Staff Report to the Planning Commission

Application Number: **06-0149**

Project Description: Proposal to divide an existing 1.05 acre parcel into 3 lots.

Environmental Planning Completeness Comments

SHEET
 A1.2

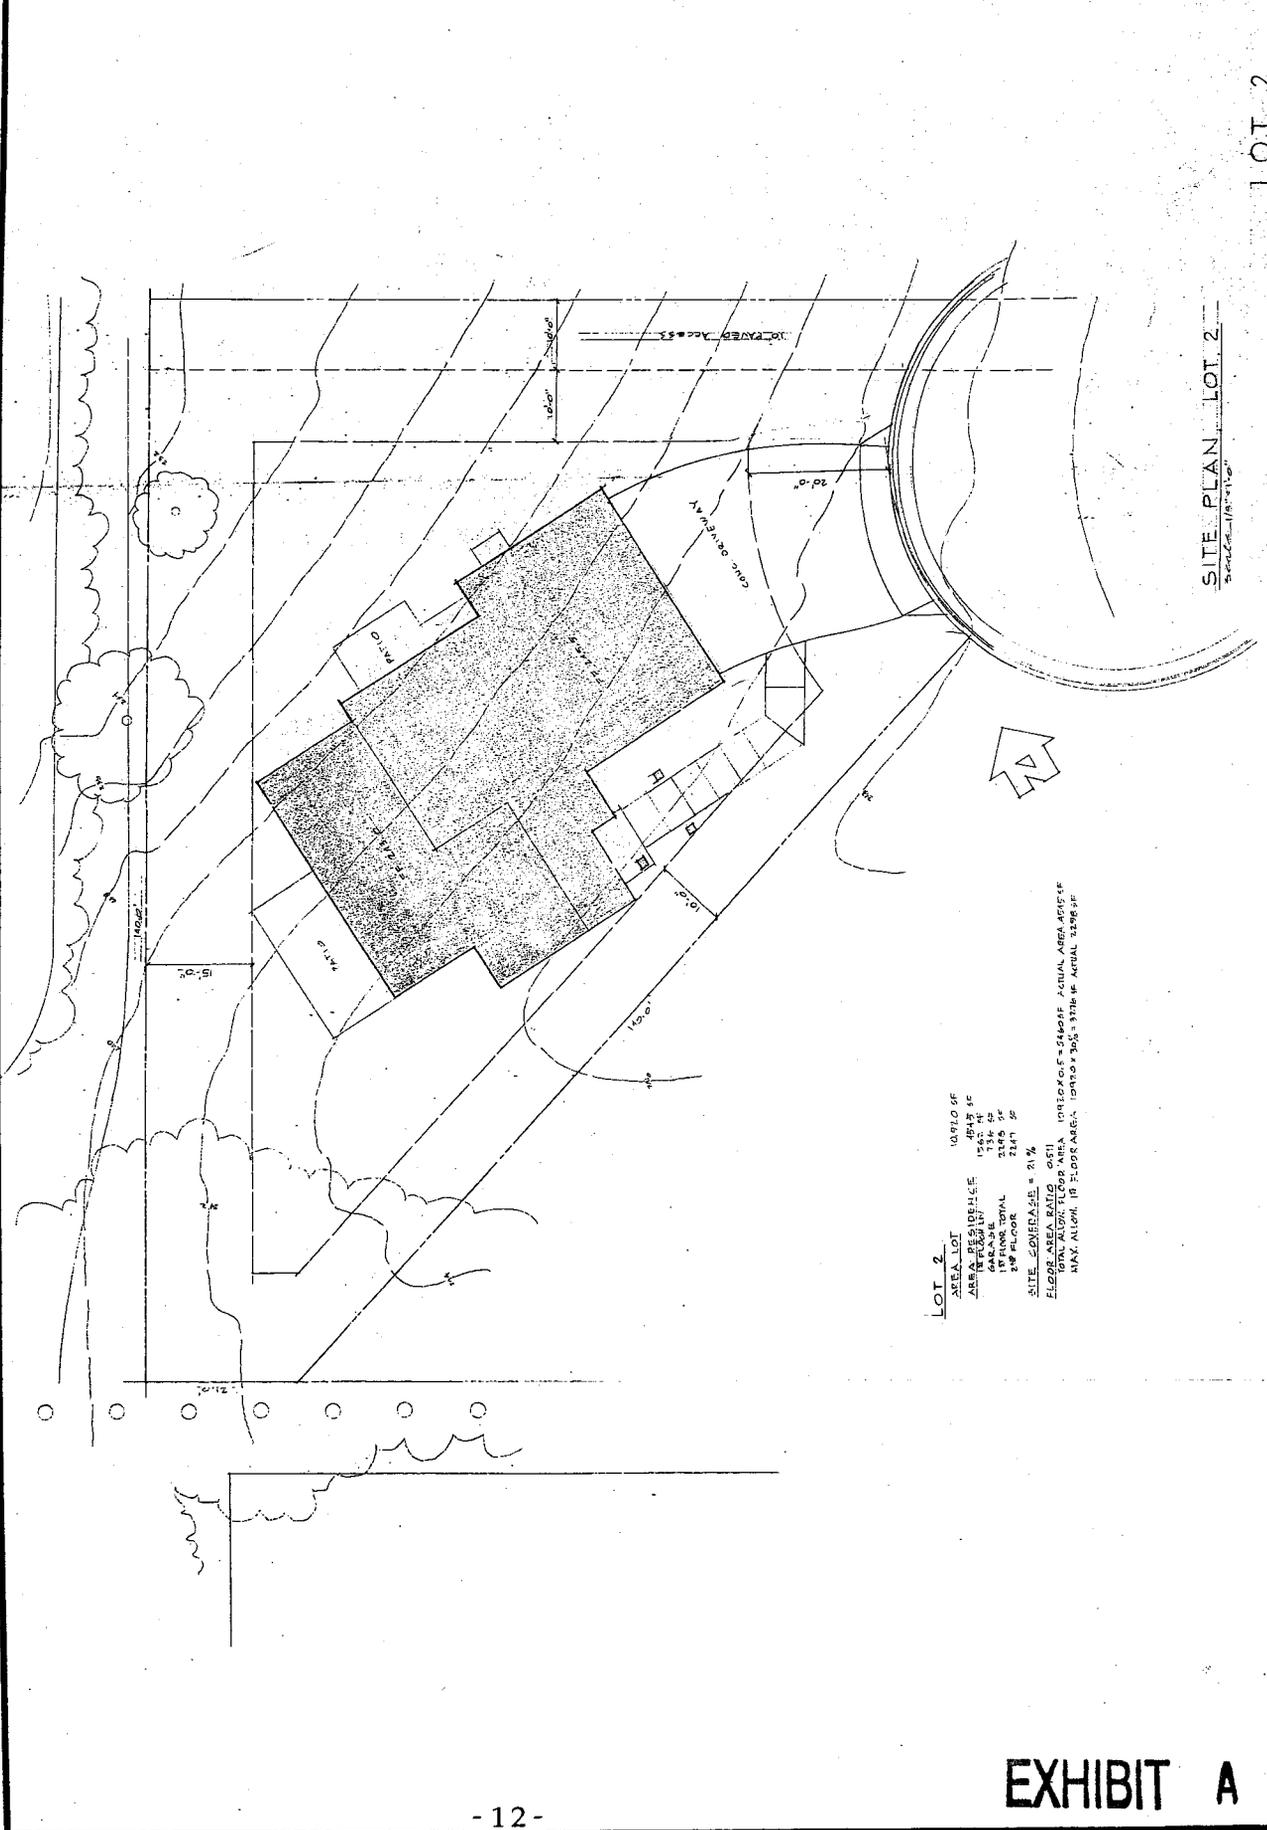
3. Plans must clearly show how drainage will be directed away from the SE side of the proposed house on lot 2.
4. Revise the geotechnical notes on Sheet TM2 from "shall be included on the final site grading and improvement plans" to "are incorporated into these plans."
5. Show the limits of grading line.
6. Include grading x-sections through the proposed structures that are perpendicular to the one shown.
